Spectralink 75-76-77x2-Series

# Technical Release Notes R2, 2021

## Firmware Version PCS 21D

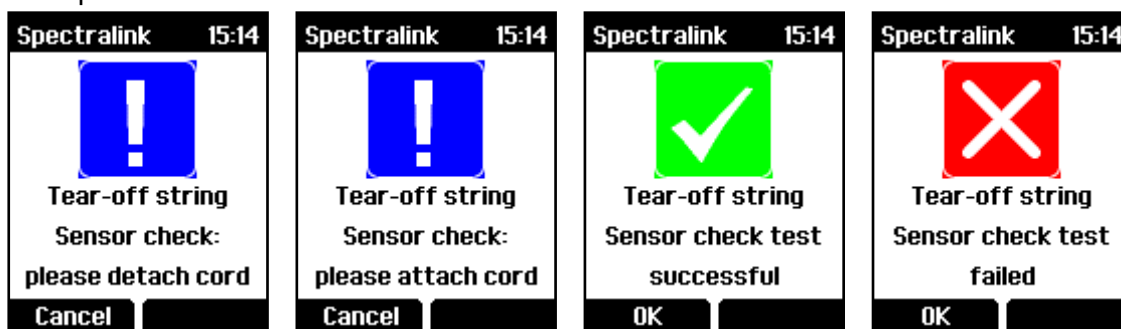
- Battery level indication icon at home screen is now always furthest to the left.
- Sensor check test user feedback and notifications improved. Pressing “OK” during sensor check test would previously hide the test notification, while the test kept running in the background. This has been changed to a “Cancel” option instead, and the notification will be shown as long as the test is active. Furthermore, notification for failed sensor test has been added, and notification for successful sensor test improved. See example for tear-off below:

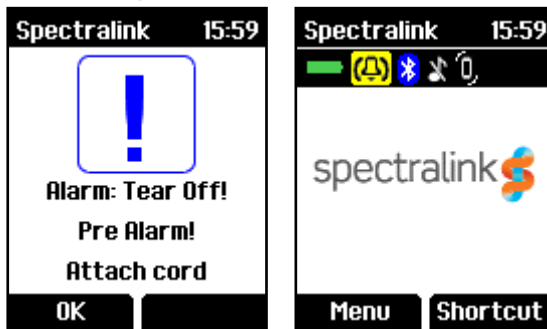
- Alarm user settings for Tear-off string, Running detector and Man down detector, in the advanced settings menu, now includes the settings: Off, Send MSF, Speed dial, Pre alarm and Loudspeaker for Speed dial.
- Alarm user feedback and notifications improved. Alarm notifications will now be shown as long as the user has not confirmed with “OK”. Pre-alarm will keep notifying every few seconds as long as the pre-alarm condition is not resolved. The notification includes name of the pre-alarm type and instructions for disabling it. Furthermore, a yellow bell indication icon is shown at the home screen, as long as an alarm notification is active. See example for tear-off below:
